**ASSESSMENT OF
ENVIRONMENTAL ISSUES
FOR THE PROPOSED
KYOTO ENERGY PARK –
AVIATION**

Client	Pamada Pty Ltd
Contact	Mark Dixon
Document No	2621/PR/004
Issue No	C
Status	Final
Classification	Client's Discretion
Date	28 August 2008

Response to Aviation Issues
from the Department of Defence
(12 March 2008)

PROPOSED KYOTO ENERGY PARK - SCONE NSW

Figure 8 NDB sloping protection surface overlaid with terrain surface + 150m (revised 42 turbine layout)

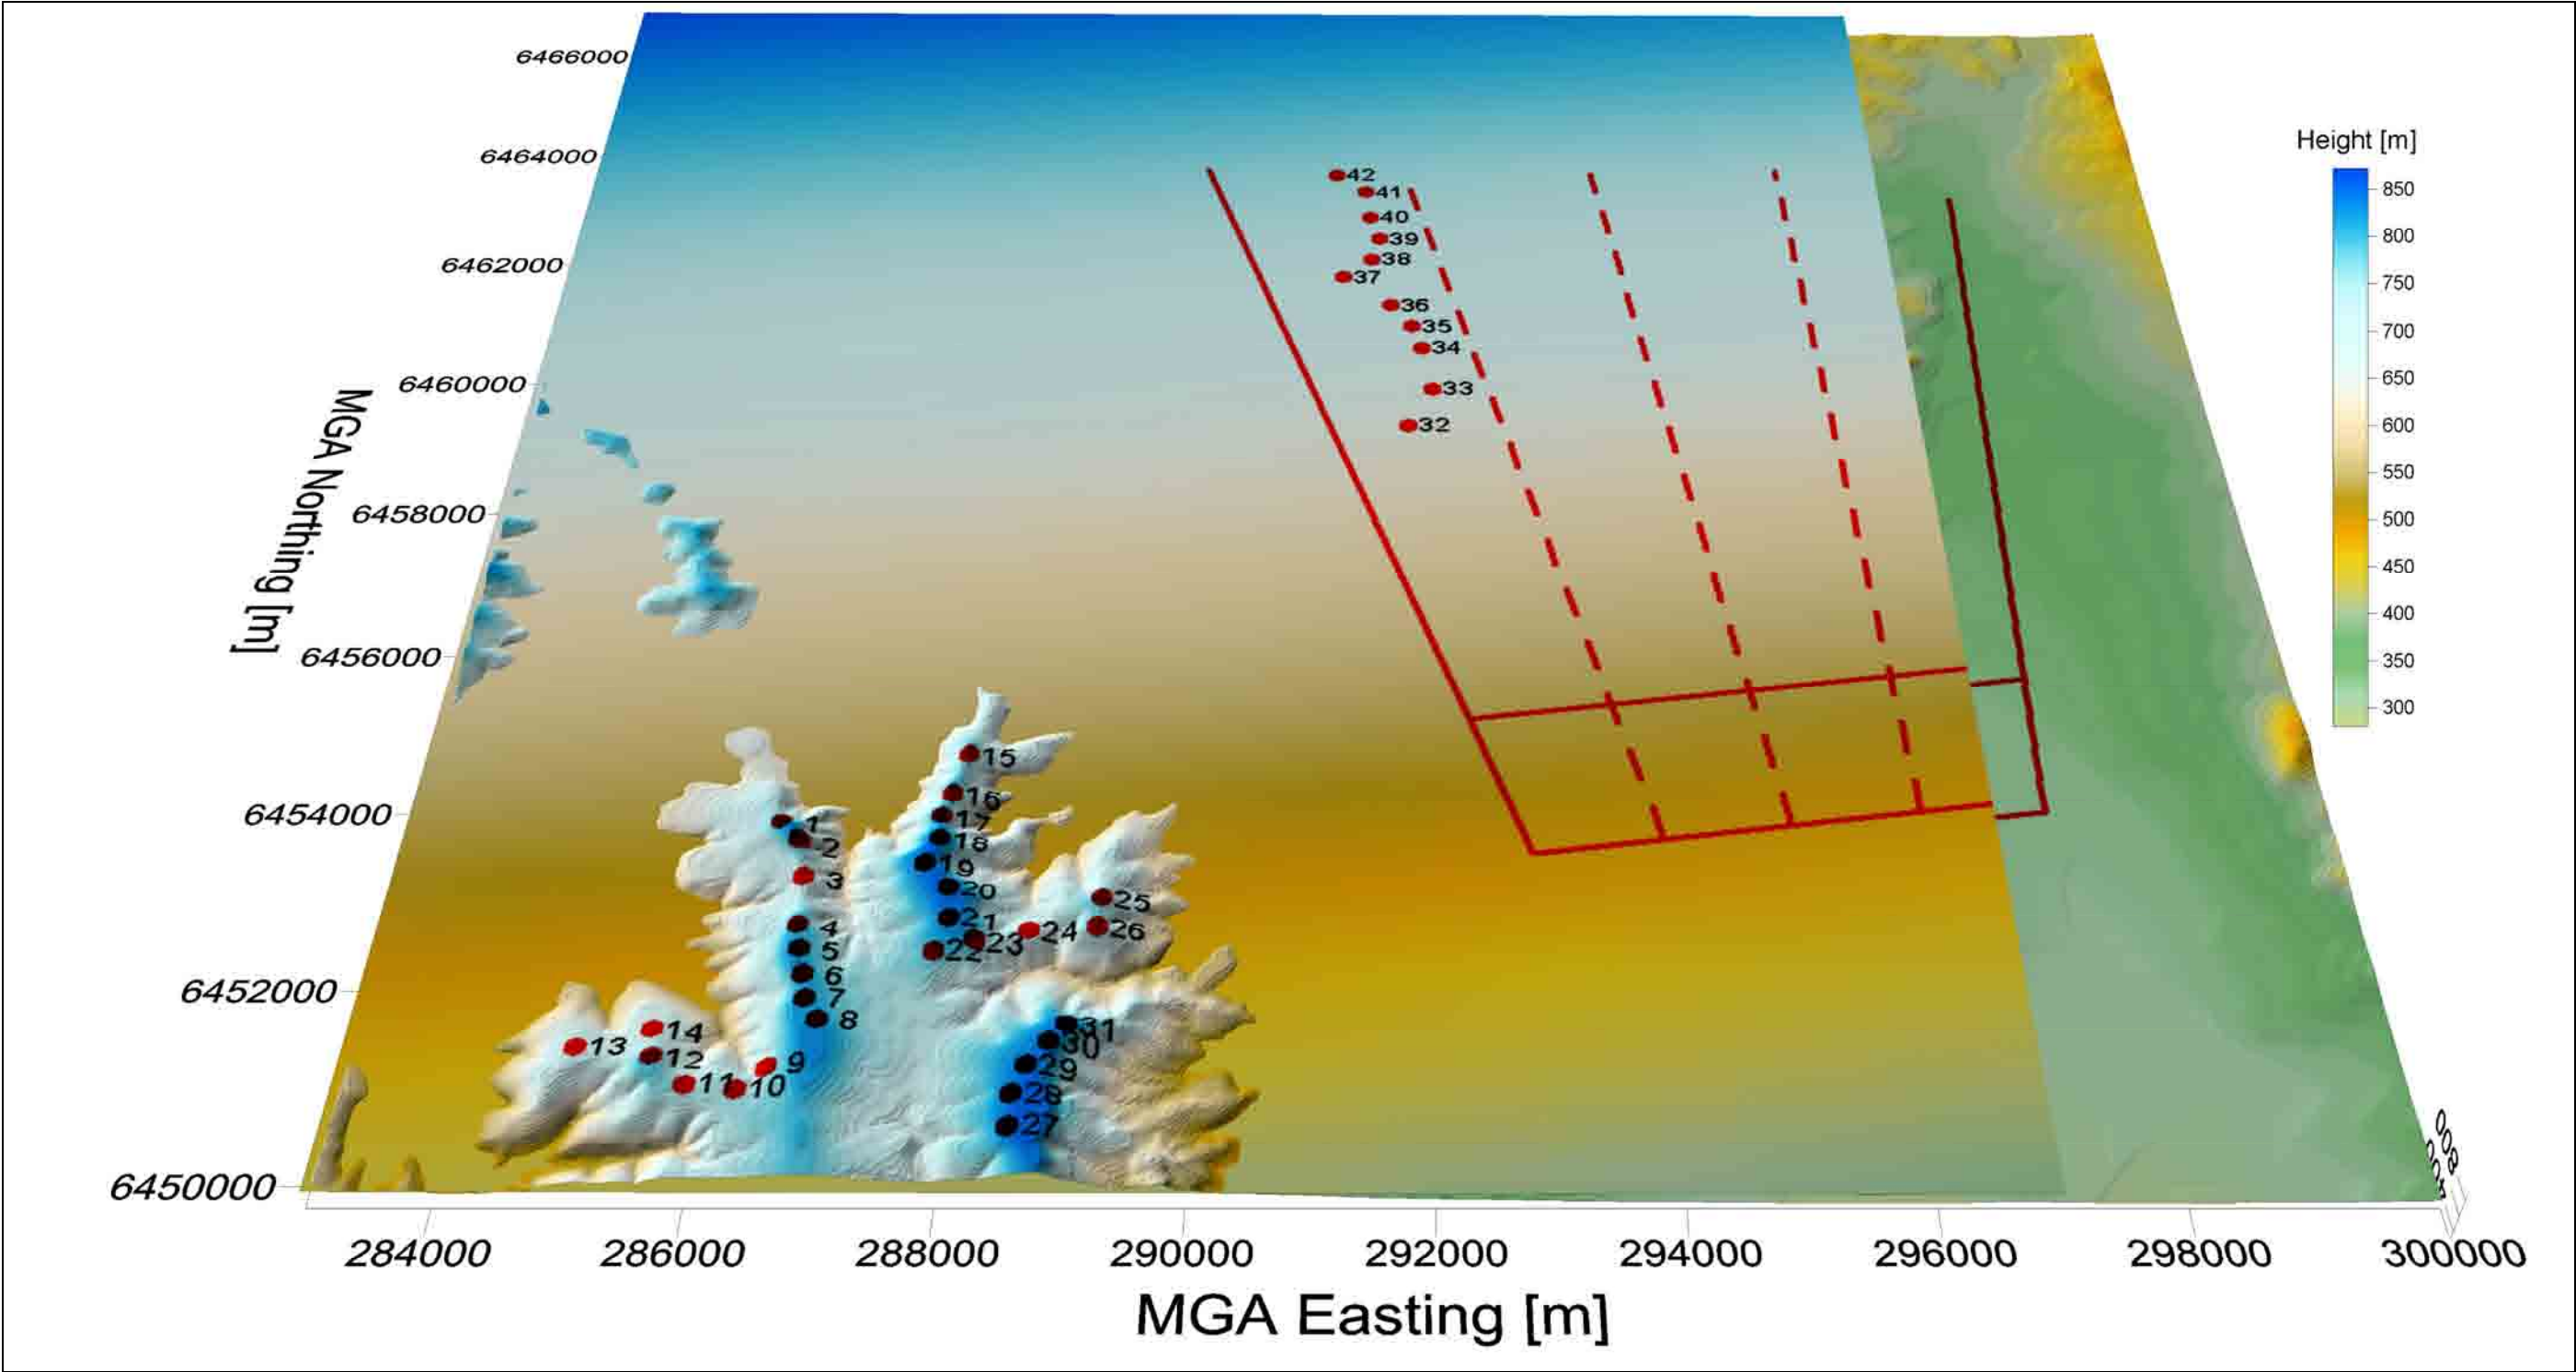
Airservices Australia indicated that turbine 40 from the old layout infringed the NDB procedure [7]. GH could not confirm this within the accuracy of our modelling process, however this finding is superseded by the fact that turbine 40 from the old layout already infringed the 29RNAV procedure as detailed above.

In the revised 42 turbine layout, turbine 36 is closest to turbine 40 in the old layout. GH could not confirm within the accuracy of our modelling process that turbine 36 from the revised layout infringed the NDB procedure, however this finding is superseded by the fact that turbine 36 already infringed the 29RNAV procedure as detailed above.

Figure 9 CAT C Circling protection procedure.

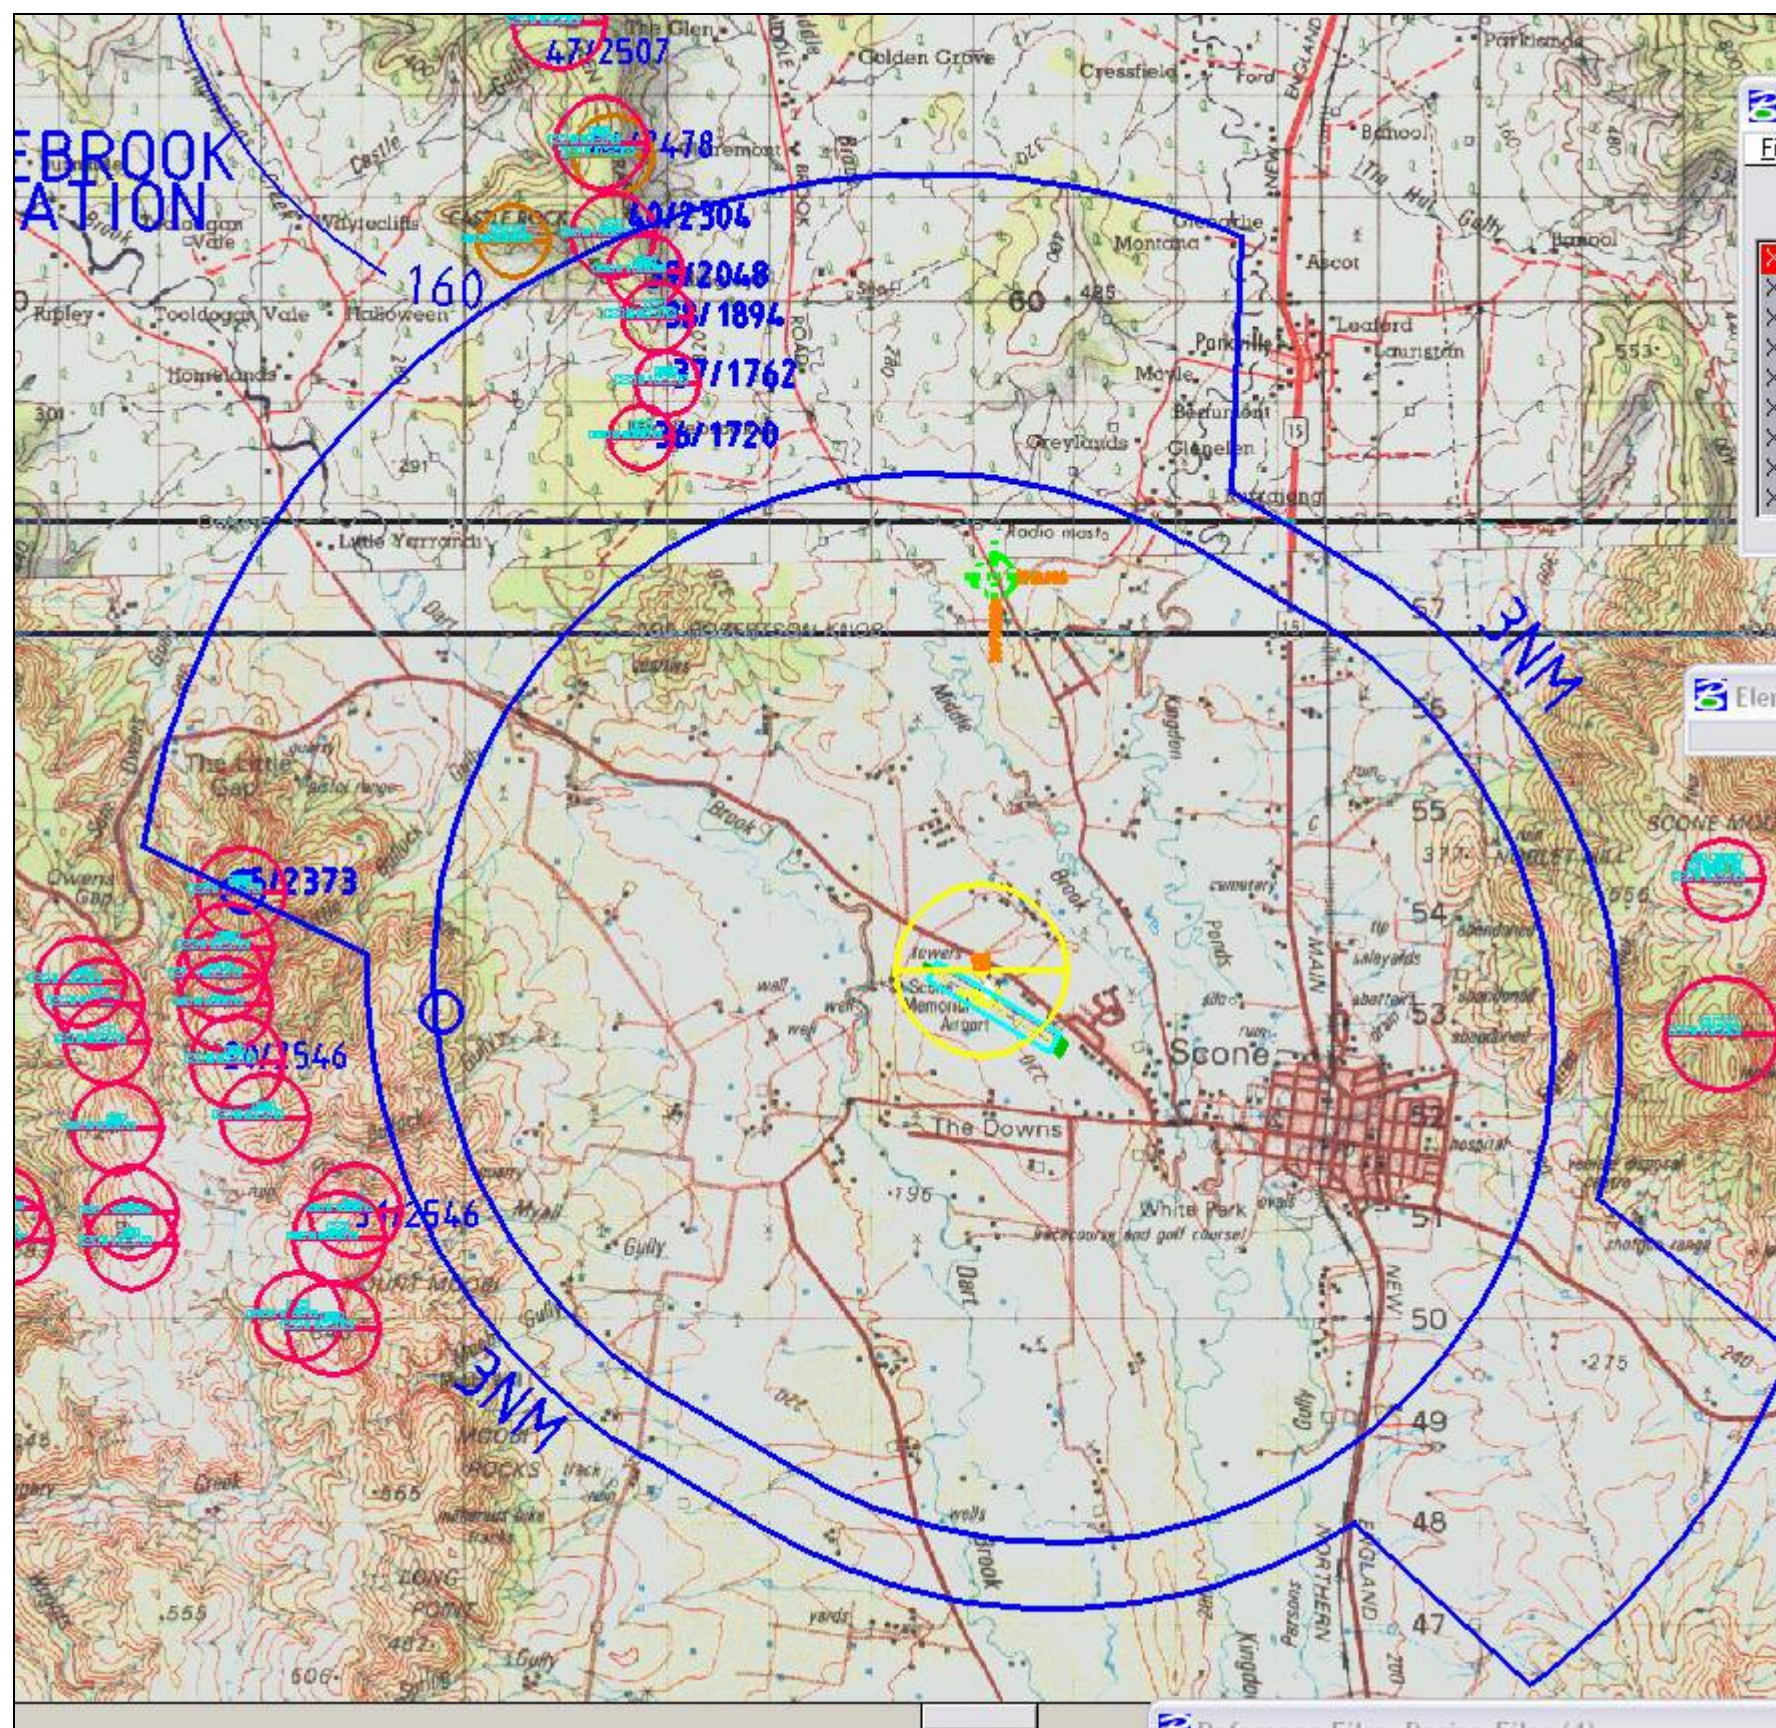
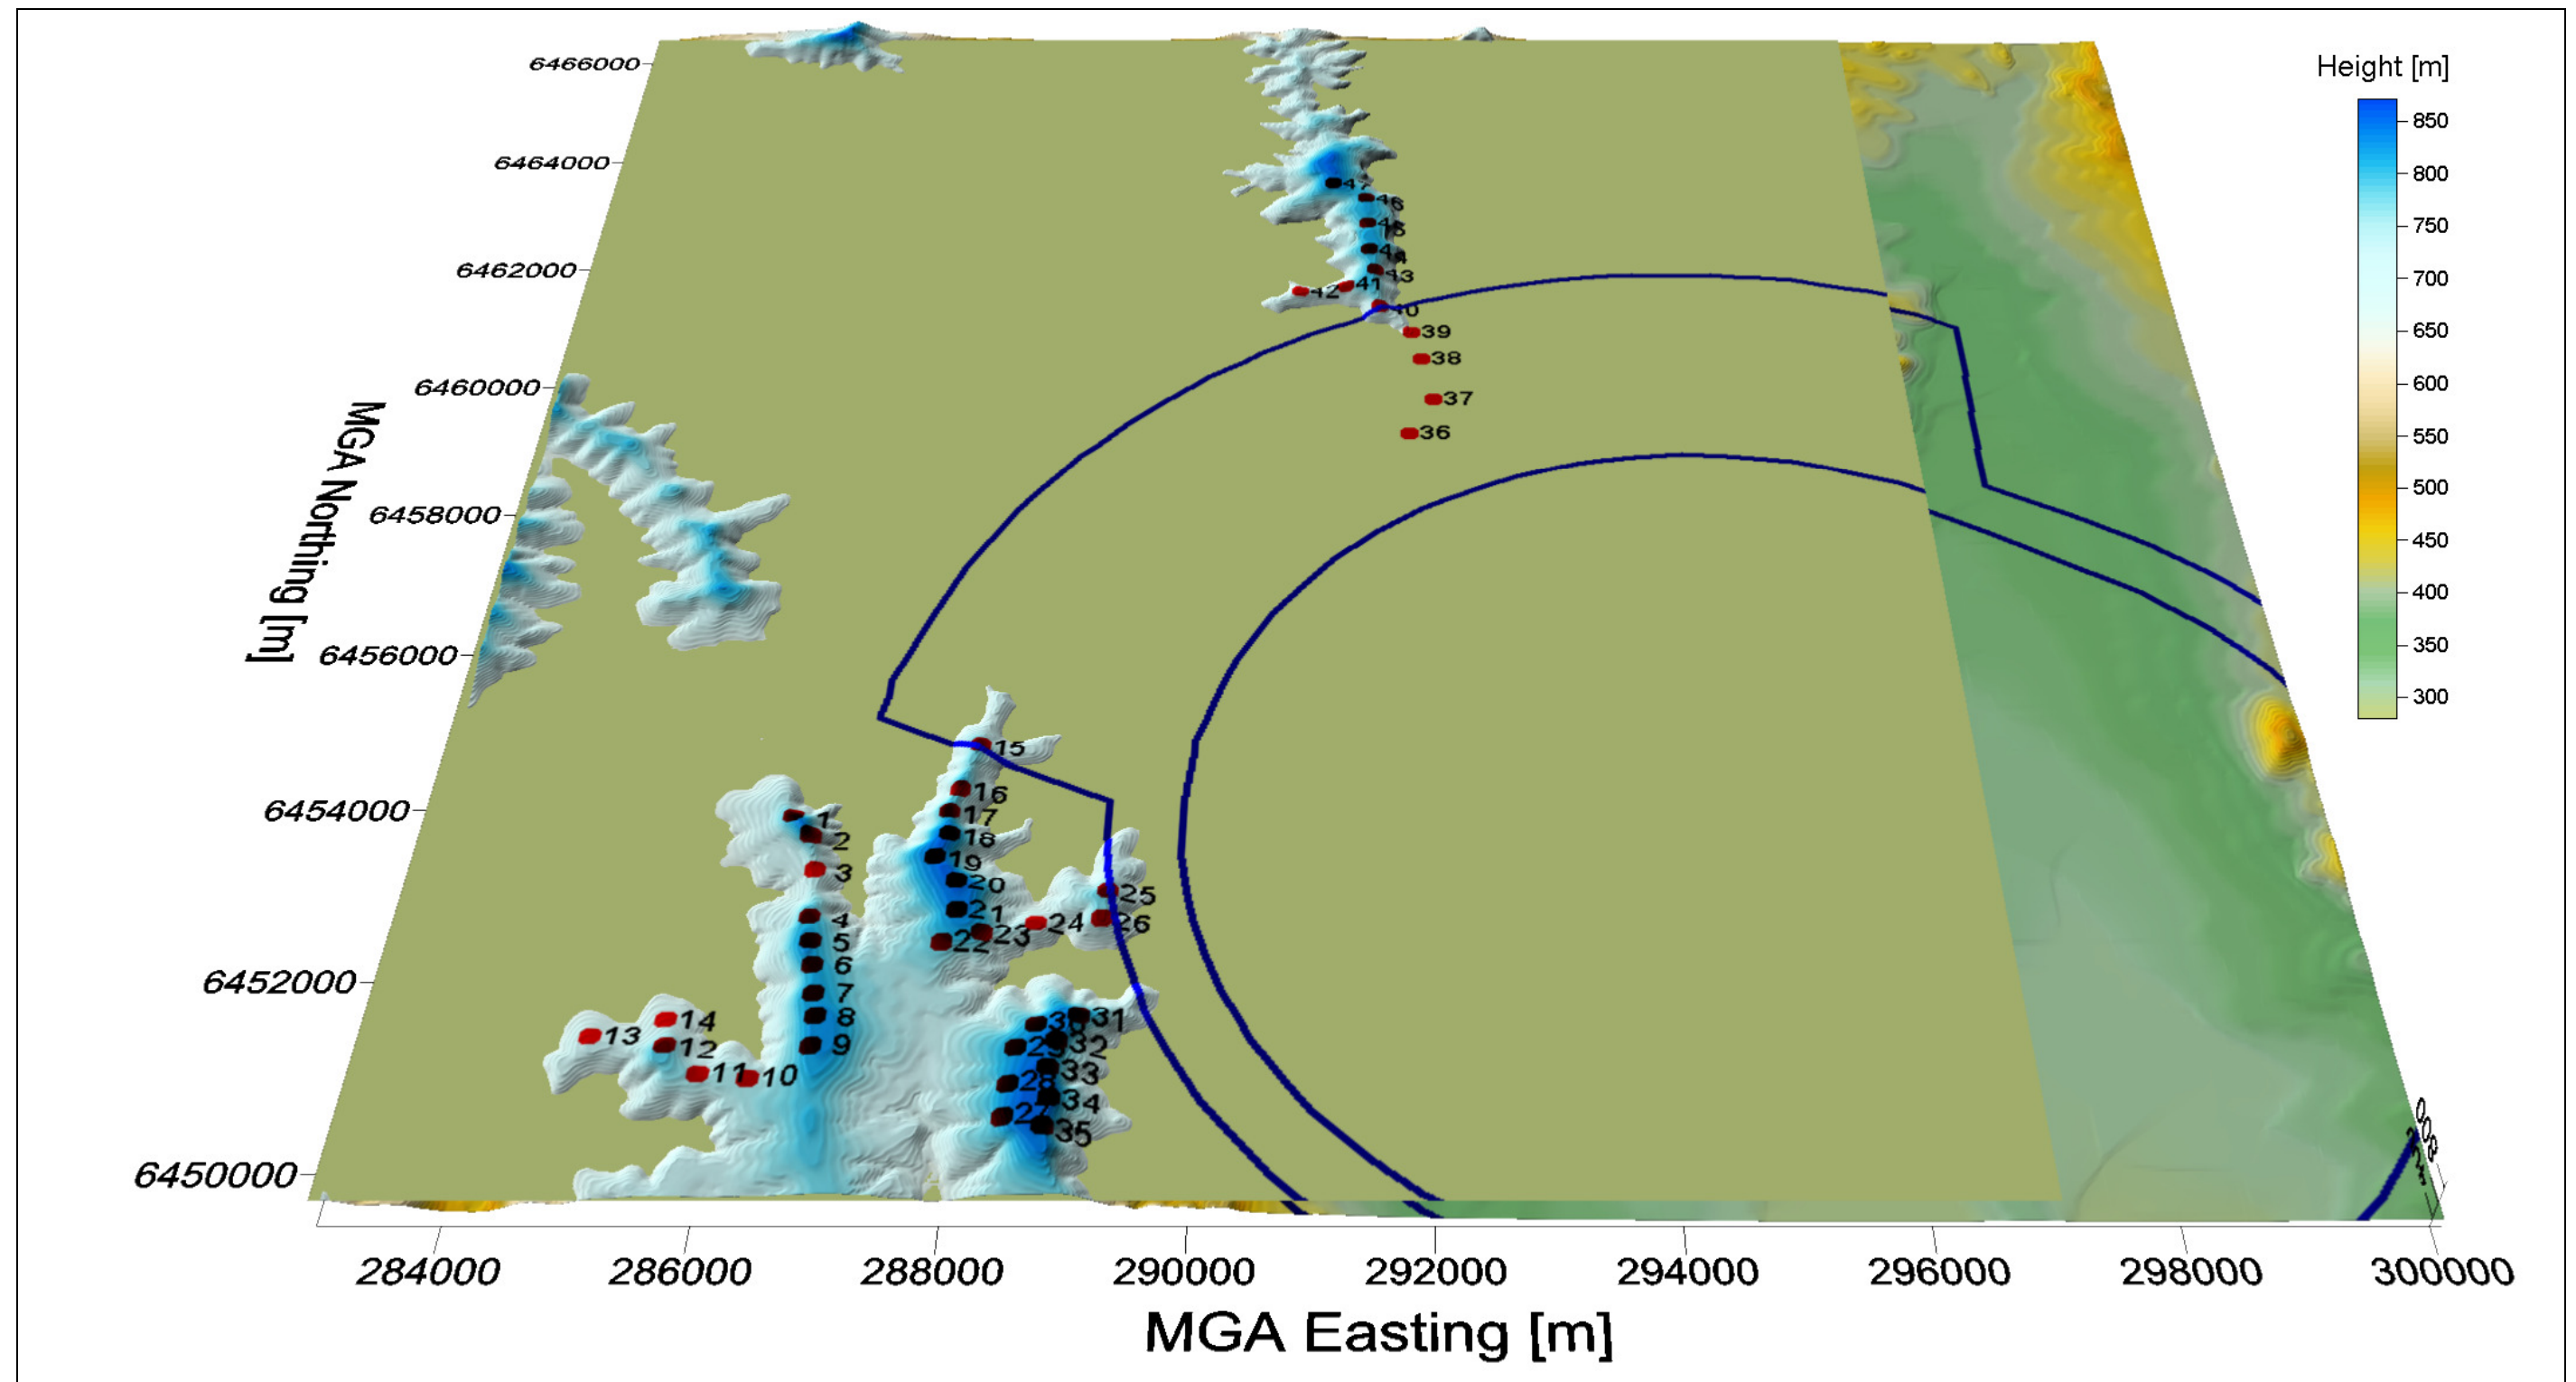
Airservices Australia indicated that turbines 15 and 39 from the original 47 turbine layout infringed the CAT C Circling procedure [7]. GH concurred with this finding.

As discussed in Section 3.2.1 turbine 15 was relocated 80m to the south and now avoids infringing the CAT C Circling procedure.

Turbine 36 from the revised 42 turbine layout still infringes the CAT C Circling procedure, however this finding is superseded by the fact that turbine 36 already infringed the 29RNAV procedure as detailed above.
